UNITED STATES PATENT AND TRADEMARK OFFICE

APPLICATION NO.	FILING DATE	FIRST NAMED INVENTOR	ATTORNEY DOCKET NO.	CONFIRMATION NO.
10/748,448	12/30/2003	Jeff Ondria	1671-0285	2398

Office Action Summary	Application No. 10/748,448	Applicant(s) ONDRLA ET AL.	
	Examiner Javier G. Blanco	Art Unit 3738

DETAILED ACTION

Figure 1:

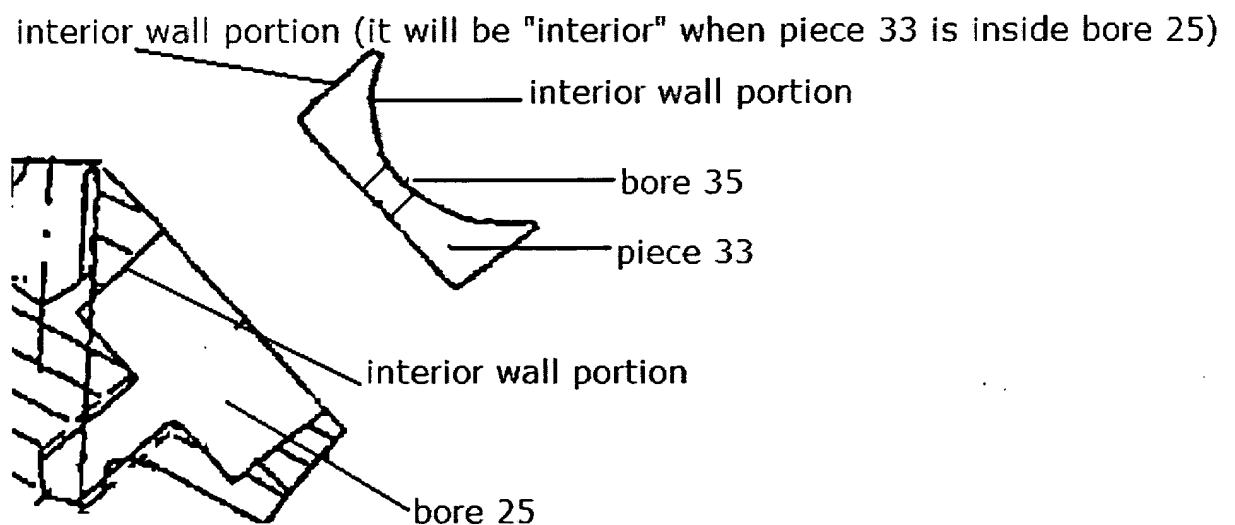
Screw 53 is configured to force articulating face 43 against the interior wall of bore 25 (via piece 33) or the interior wall of bore 35 (when piece 33 is inserted into bore 25). The interior wall portion could be: (i) a portion of the interior wall of bore 25; (ii) a portion of wall 34 (it will be “interior” once piece 33 is inserted into bore 25); and/or (iii) a portion of the interior wall of bore 35. Any of these “interior wall portions” extends from a proximal surface of the stem in a straight line. Also, articulating face 43 touches the internal bore around substantially an entire perimeter of the internal bore defined by the intersection of a plane (note: the “plane” is not defined in the claim language) with the internal bore. Below is a representation of Bahler’s

b. Regarding claim 27, it should be noted that the claim language requires "a proximal surface that defines a coupler opening". Below is a representation of Glien et al.'s Figure 3:

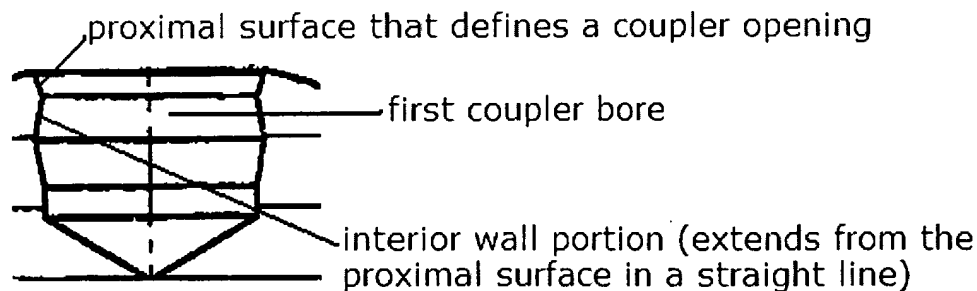
Based on this representation (and as seen in Figures 4 and 5), the “*spherical articulating portion of the mounting element touches the interior wall portion at a point along the straight line*”.
